DeKalb County Historic Preservation Commission

Staff Report

K. 1761 South Ponce de Leon Avenue, Karen Soorikian. Replace windows on a historic house.
1247462

1761 South Ponce de Leon Avenue - Window Replacement Proposal

WINDOW AND EXTERIOR DOOR SCHEDULE

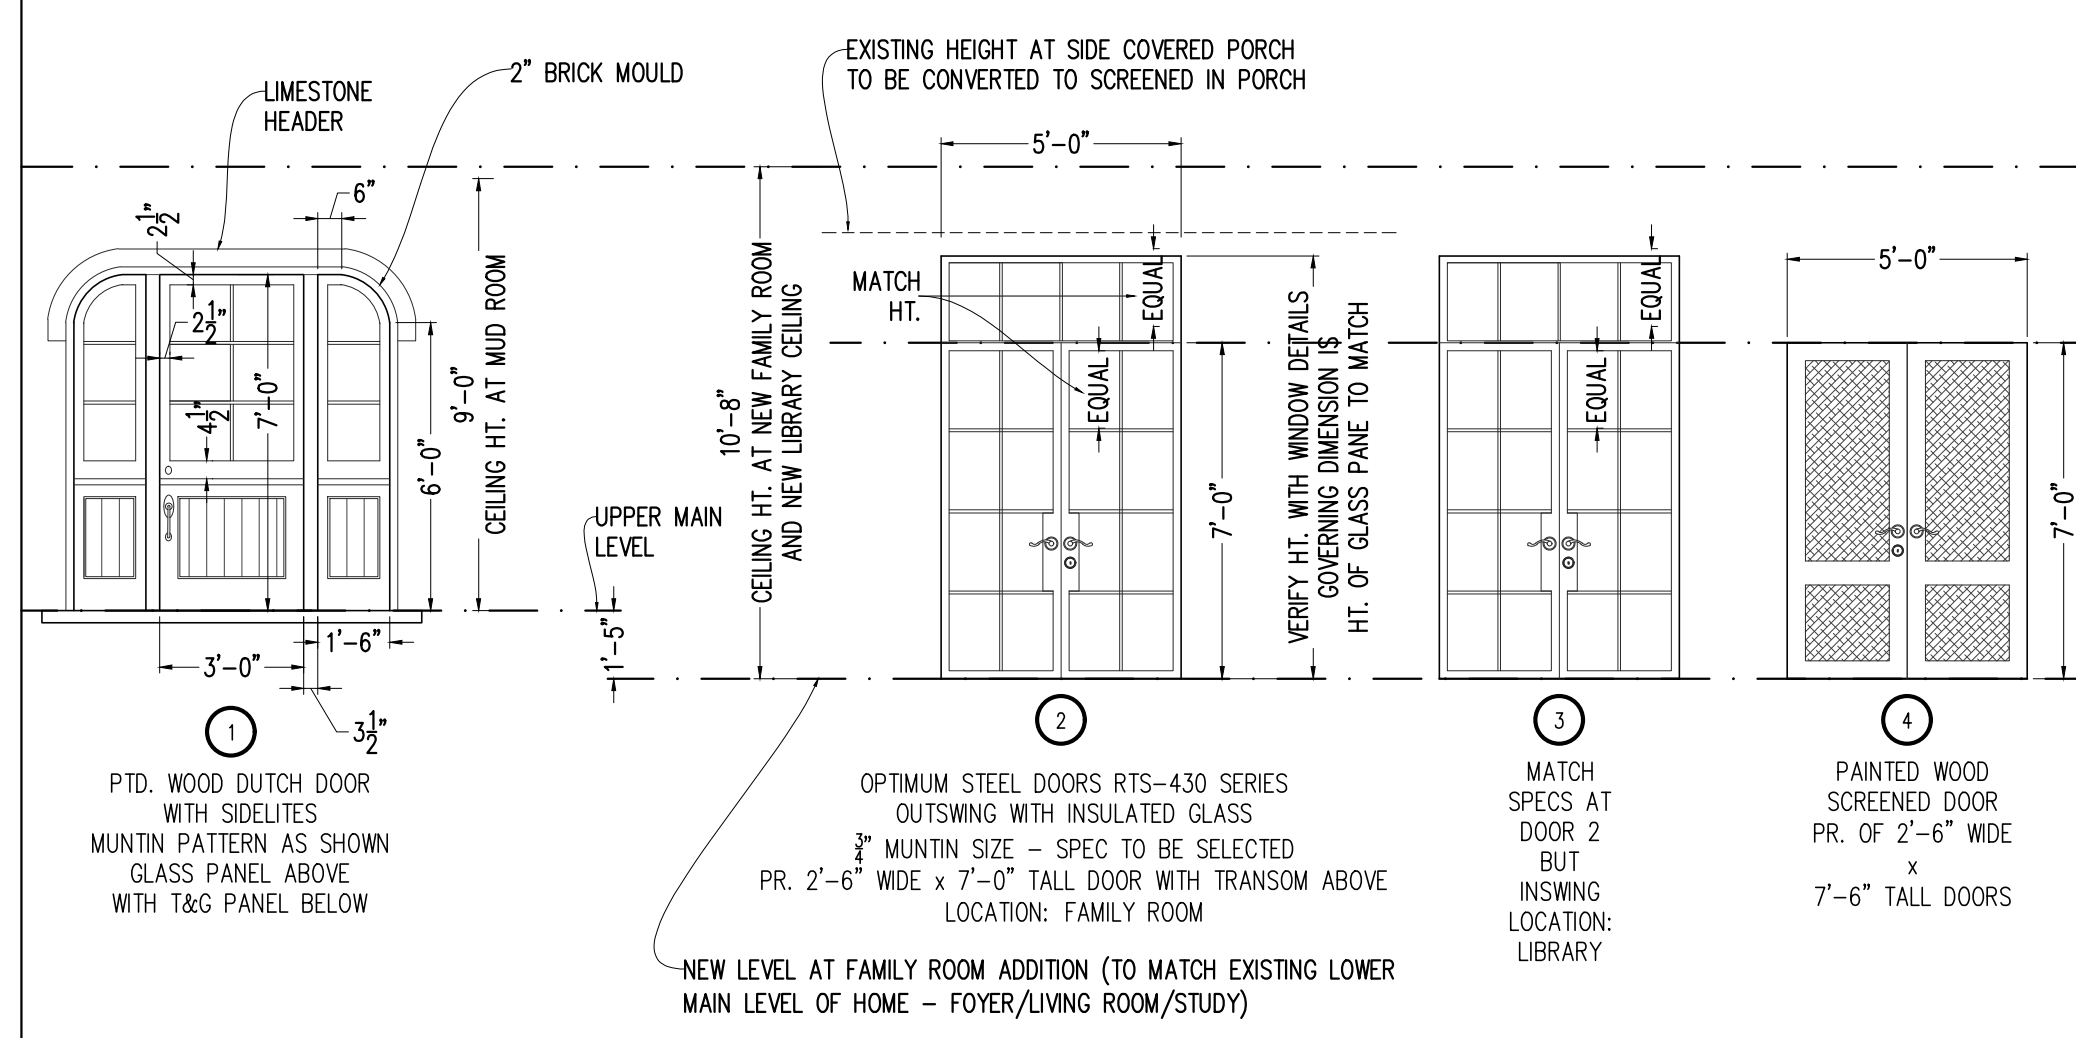
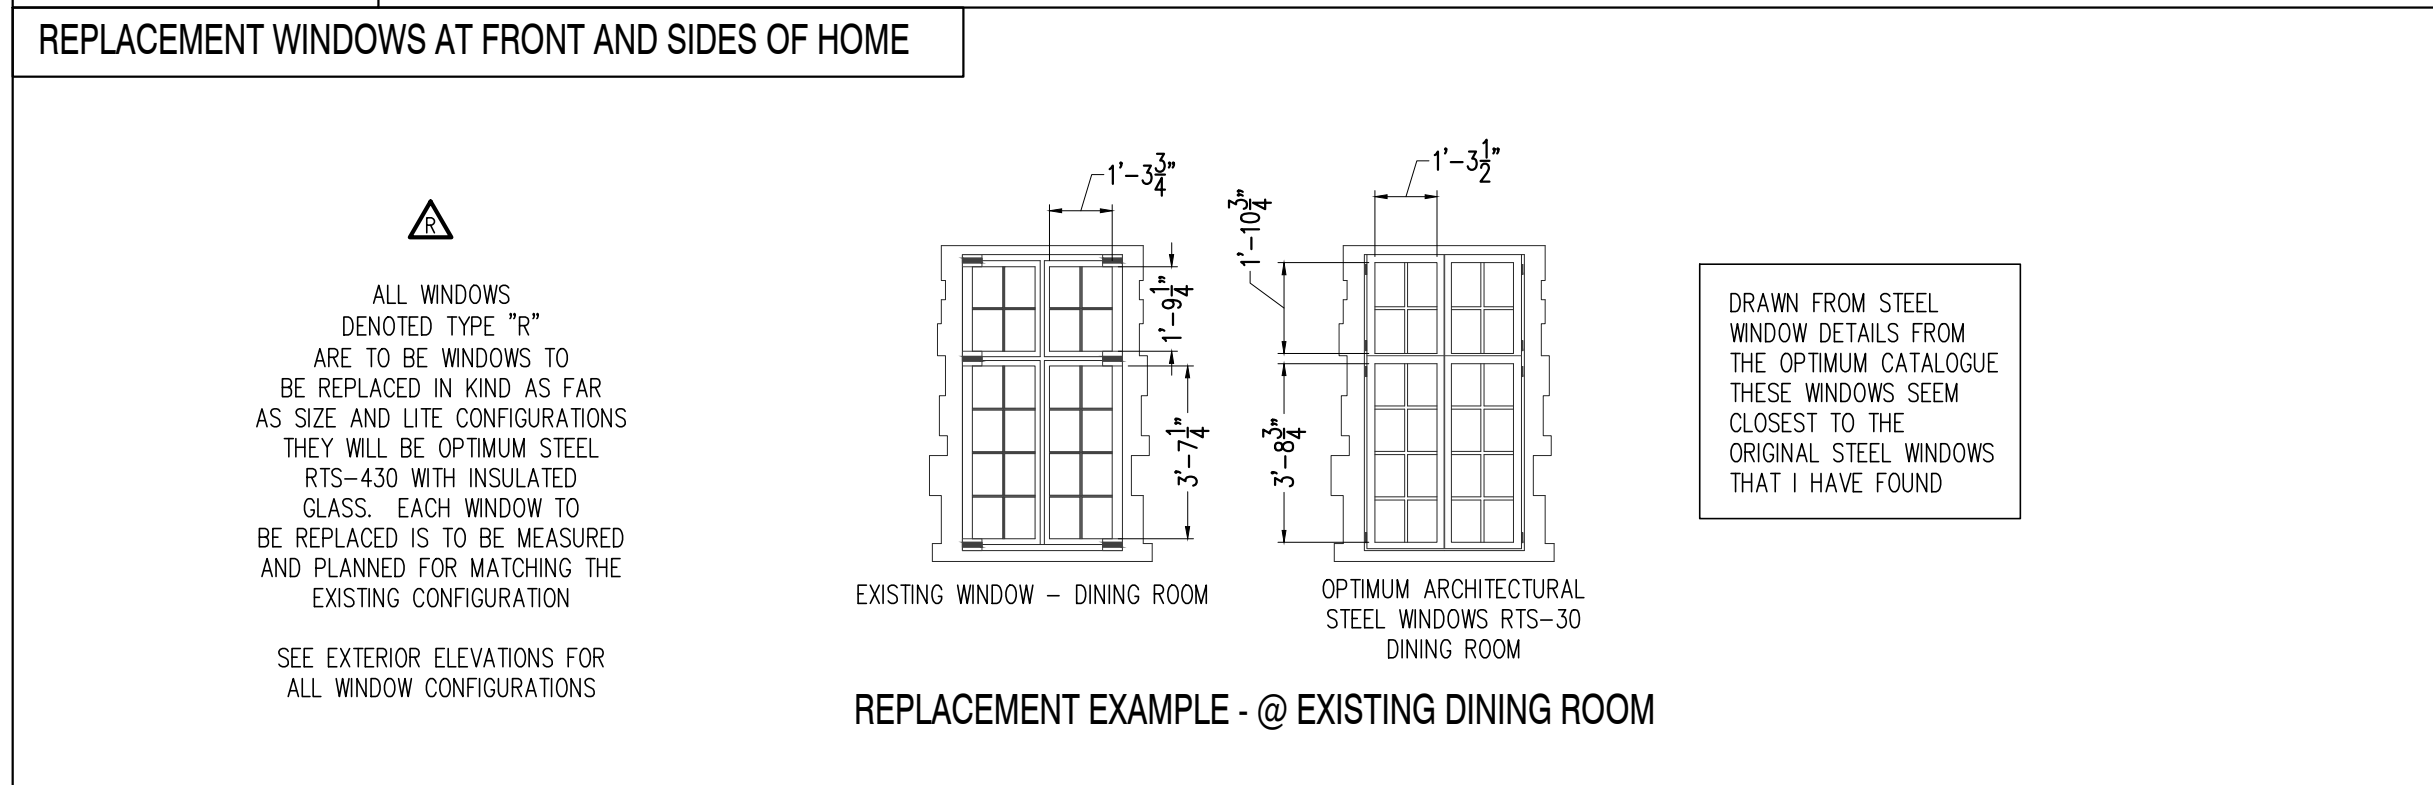
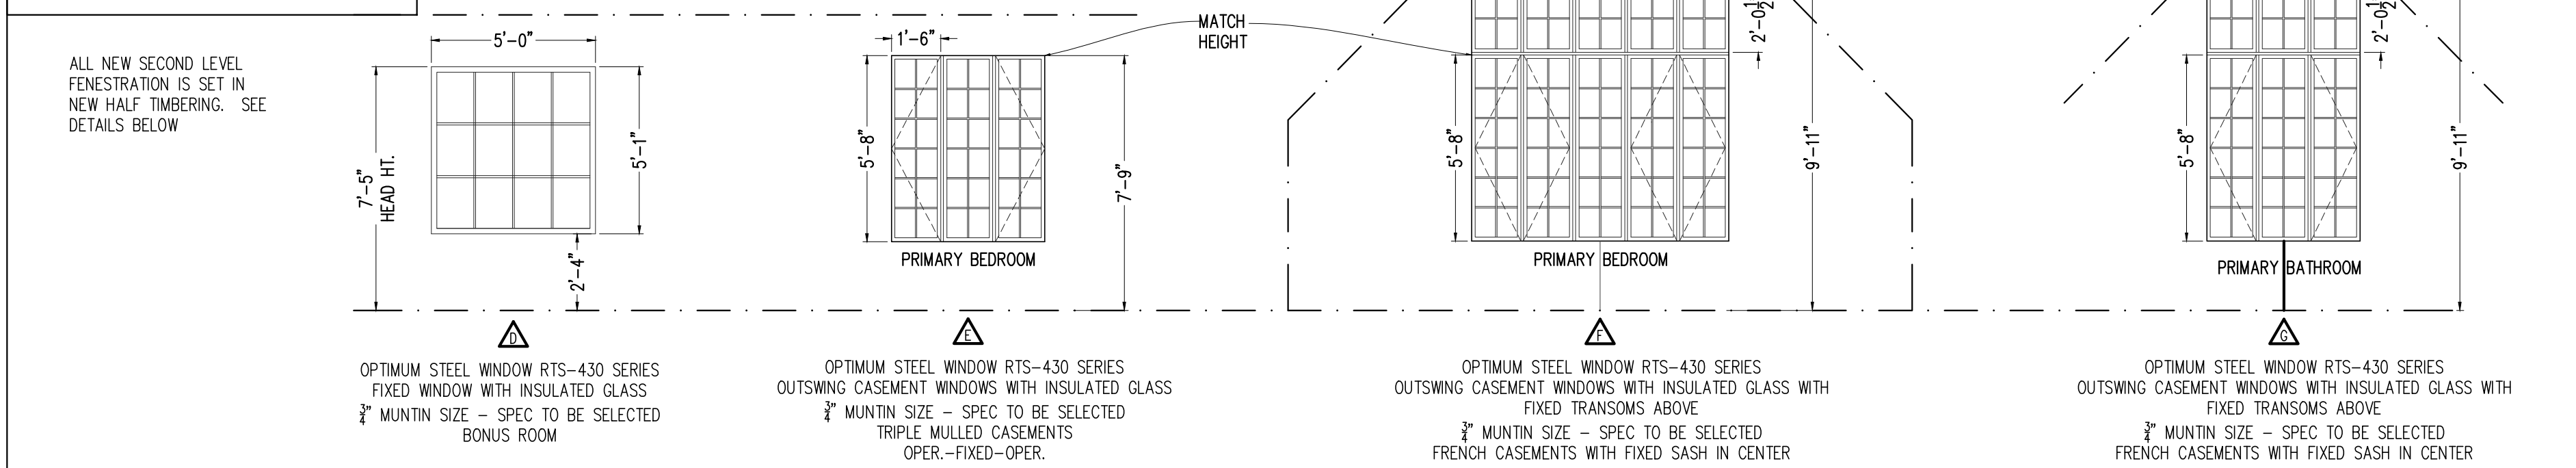
NOTE:
SEEKING COA FOR THIS: ALL EXISTING STEEL AND GLASS WINDOWS AT HOUSE ARE TO BE REPLACED WITH NEW INSULATED OPTIMUM STEEL WINDOWS RTS-430 SERIES.

Approve with Modifications. The applicant may replace windows located on the side and rear elevations of the property and remove the nonhistoric storm covers; however, the windows on the front façade of the house should be retained and repaired if possible and only replaced if the windows cannot be repaired, in accordance with guideline 6.1.4.
